**ZONING AMENDMENT,
PLANNED UNIT DEVELOPMENT &
SUBDIVISION STAFF REPORT**

Date: September 4, 2003

Brookview at Brookside Subdivision

SITE PLAN

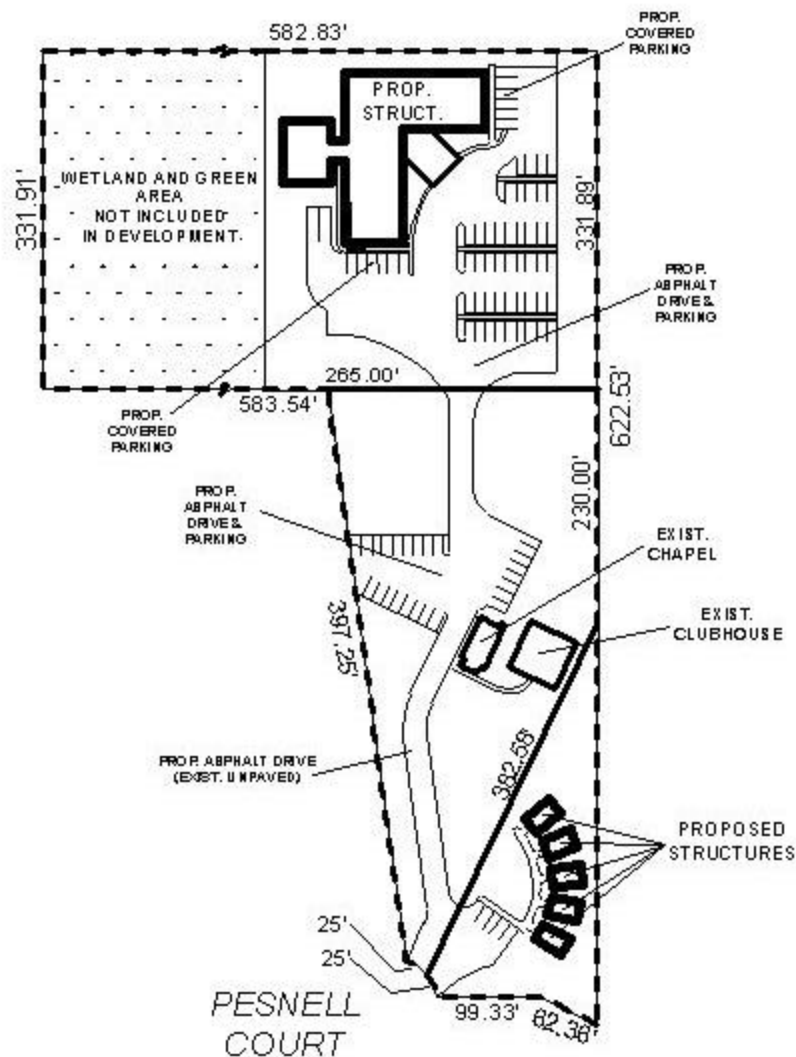
Recommend holdover. The applicant has initiated the clearing phase of construction without a permit and the site plan does not show existing contours as required by the Subdivision Regulations. The proposed development appears to encroach over a major drainage easement that conveys storm flows from a significant watershed to the East. In addition, it is the Engineering Department's

understanding that the proposed site also includes wetlands that are not shown on the plans. If this site is approved for development at all, significant changes may be required to comply with the Storm Water Ordinance.

As outlined above, City Engineering has numerous concerns regarding the proposed project. It should be noted that Planned Unit Development approval is site plan specific, and as outlined in the Engineering Comments, significant changes may be required to comply with City Ordinance(s). Additionally both PUD and R-3 zoning are proposed, and as a condition of rezoning, the Planning Commission and City Council typically

require that the property be developed in accordance with the associated PUD. Moreover, as referenced in the Engineering Comments, the Subdivision Regulations require contour information, as well as the location of easements, water courses, marshes and other significant features to be shown on the preliminary plat. It should also be noted that as illustrated on the Vicinity Map, it appears that the overall parcel from which the rezoning site is being taken is not included in the Subdivision application, and if the balance is not included, it would be land-locked.

Based upon the preceding, all three applications are recommended for holdover until the October 2nd meeting to allow the applicant to provide the following information: 1) the balance of the property from which the rezoning site is being taken; 2) contours and/or spot elevations as required by Section IV.A.2.b. of the Subdivision; 3) the location, width and purpose of existing and proposed easements as required by Section IV.A.2.g. of the Subdivision Regulations; 4) the location of water courses, marshes and other significant features as required by Section IV.A.2.i. of the Subdivision Regulations (this would include wetlands). This information must be submitted by September 15th to allow adequate time for review prior to the October 2nd meeting.
